National Transportation Safety Board

Safety Recommendation

Date: November 23, 2010

In reply refer to: A-10-136 through -147

Figure 1. Engine control quadrant on a Sikorsky S-76C++ helicopter.

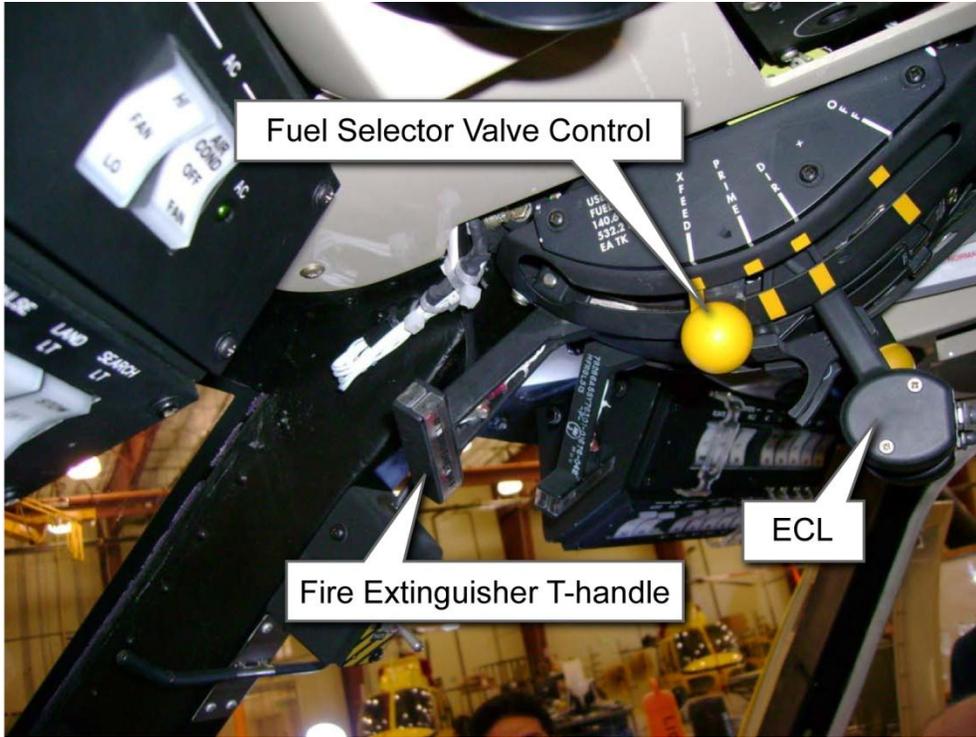
The Sikorsky S-76C++ helicopter has an overhead engine control quadrant that houses two engine fire extinguisher T-handles, two engine power control levers (ECL), two fuel selector valve control levers, and switches for other essential functions (see figure 1). The fire extinguisher T-handles, which are located about 4 inches aft of the captain's and first officer's windshields, are normally in the full-forward position during flight and are held in place by a spring-loaded pin that rests in a detent; aft pulling force is required to move the handles out of their detents (see figure 2). In the event of an in-flight engine fire indication, the flight crew is instructed, in part, to move the affected engine's fire extinguisher T-handle full aft so that a mechanical cam on the T-handle pushes the trigger on the ECL out of the wedge-shaped stop, allowing it to physically move aft with the T-handle (pilot input is required to move the T-handle and ECL aft together); fuel to the affected engine is then reduced. The fuel flow to the engine is eventually shut off as the fire extinguisher T-handle continues aft. The fire extinguisher system is then automatically armed and ready for the pilots to release the fire extinguishing agent into the appropriate engine compartment. Sikorsky S-76C+, S-76D, and S-92A helicopters have engine control quadrant designs similar to the S-76C++ helicopter.

The NTSB concludes that impact forces on the S-76C++⁶ canopy or windshields near the engine control quadrant and the subsequent movement of T-handles, which may push the ECL triggers out of the stops and allow them to move aft and into or near the flight-idle position, could result in unexpected and substantial loss of engine power. Greater resistance to movement of the fire extinguisher T-handles would ensure that the T-handles do not become dislodged due to impact force on the canopy or windshield and cause unintended movement of the ECLs. The NTSB understands that pilots would then need to use greater force to move the T-handles; however, this resistance can be calculated so that it will not lead to operational problems for the pilots who activate the T-handles when needed and will still provide protection against unintentional movement of the T-handles and ECLs. Therefore, the NTSB recommends that the FAA require that Sikorsky redesign the S-76C++ model helicopter fire extinguisher T-handles and/or engine control quadrant to ensure that the T-handles do not inadvertently dislodge out of their detents due to any external force on the canopy or windshields that could cause unintended movement of the ECLs. The NTSB further recommends that the FAA evaluate other helicopter models with engine control quadrant designs similar to the S-76C++ model helicopter and require modification, as necessary, to ensure that any external force on the canopy or windshields does not cause unintended movement of the ECLs.

Require that Sikorsky redesign the S-76C++ model helicopter fire extinguisher T-handles and/or engine control quadrant to ensure that the T-handles do not inadvertently dislodge out of their detents due to any external force on the canopy or windshields that could cause unintended movement of the engine power control levers. (A-10-136)

Figure 2. S-76C++ fire extinguisher T-handle and ECL with trigger mechanism.

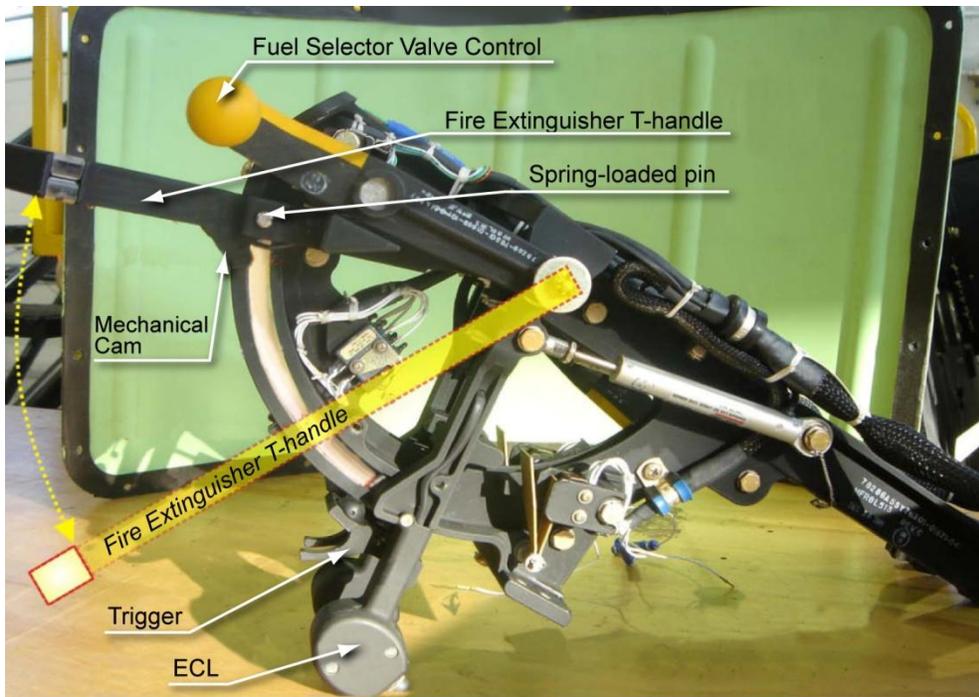
Based on the impact damage to the canopy, it is likely that the bird impacted the canopy just above the right-side windshield near the fire extinguisher T-handles. As noted, the CVR recorded a loud bang and rushing wind, immediately followed by sounds consistent with a power reduction on both engines; thus, it is likely that the bird impact shattered the windshield and jarred the fire extinguisher T-handles out of their detents and moved them aft. The momentum of the T-handles pushed both ECL triggers out of their stops and allowed them to move aft and into or near the flight-idle position. A similar incident occurred on November 13, 1999, in West Palm Beach, Florida, when a bird struck the windshield of an S-76C+ helicopter, N276TH, operated by Palm Beach County.⁵ The bird did not penetrate the laminated glass windshield, but the impact force of the bird cracked the windshield and dislodged the fire extinguisher T-handles out of their detents; however, in that case, the force was not great enough to move the ECLs.
